Note

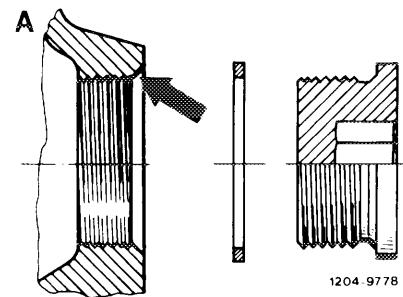
As of October 1980, the modified screw plug M 38 x 1.5 is installed together with an O-ring.

The chamfer in the crankcase was changed for this reason (2nd version).

A 1st version

B 2nd version

When installing a coolant preheater, an O-ring or sealing ring to suit the chamfer in the crankcase should be used.
